Exhibit A

Recommended Amendments to the 2018 International Building Code

****Figure R602.6.1; delete the figure and insert the following figure:**

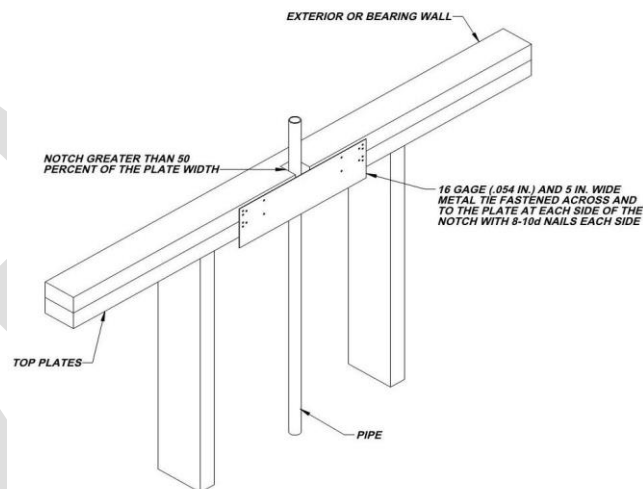
R602.6.1 Drilling and notching of top plate. When piping or ductwork is placed in or partly in an exterior wall or interior load-bearing wall, necessitating cutting, drilling or notching of the top plate by more than 50 percent of its width, a galvanized metal tie not less than 0.054 inch thick (1.37 mm) (16 Ga) and 4 ½ inches (38) mm 5 inches (127 mm) wide shall be fastened across and to the plate at each side of the opening with not less than eight 10d (0.148 inch diameter) having a minimum length of 1 ½ inches (38 mm) at each side or equivalent. Fasteners will be offset to prevent splitting of the top plate material. The metal tie must extend a minimum of 6 inches past the opening. See figure R602.6.1. *{Remainder unchanged}*

(Amendment to 2015 IRC carried forward to 2018 IRC also provides additional assurance of maintaining the integrity of the framing by spreading the nailing pattern.)

ADD: Figure: 25 TAC §265.186 (e) (6)

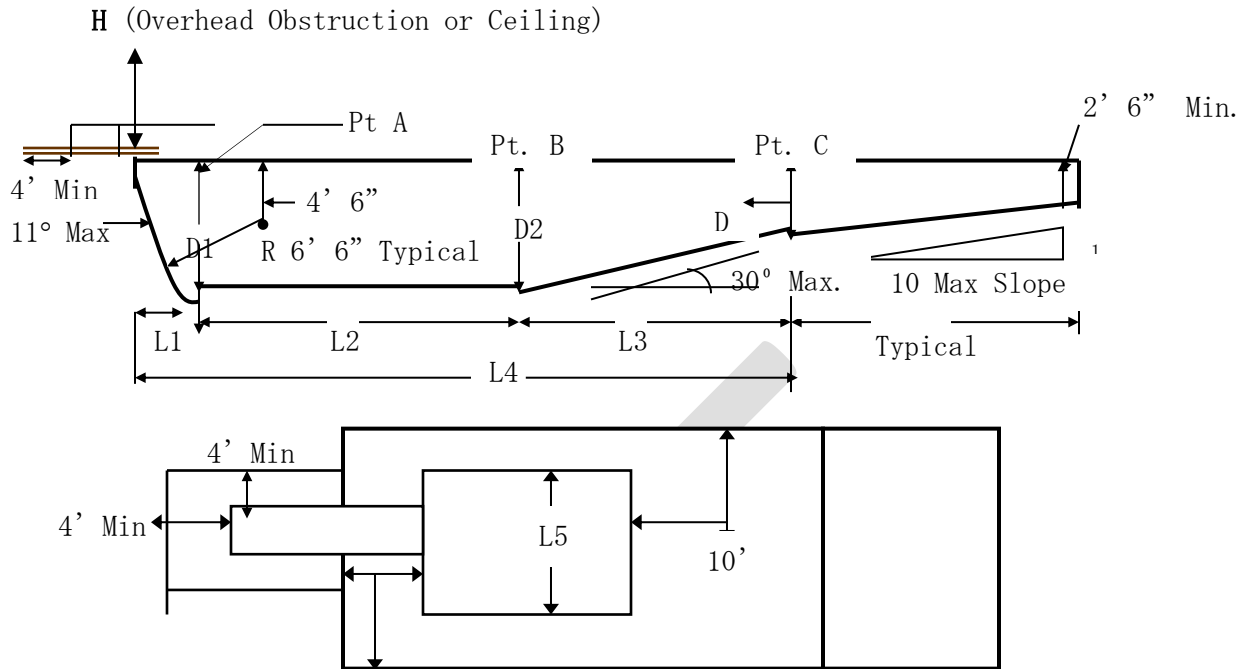
402.12 Water envelopes. The minimum diving water envelopes shall be in accordance with ~~Table 402.12 Texas department of State Health services, Administrative Code Title 25, Chapter 265, Section 186 (e) and Figure: 25 TAC 256.186 (e) (6).~~ (Delete Table 402.12 and Figure 402.12)

(Reason: To avoid conflict with 25 TAC Chapter 265.)
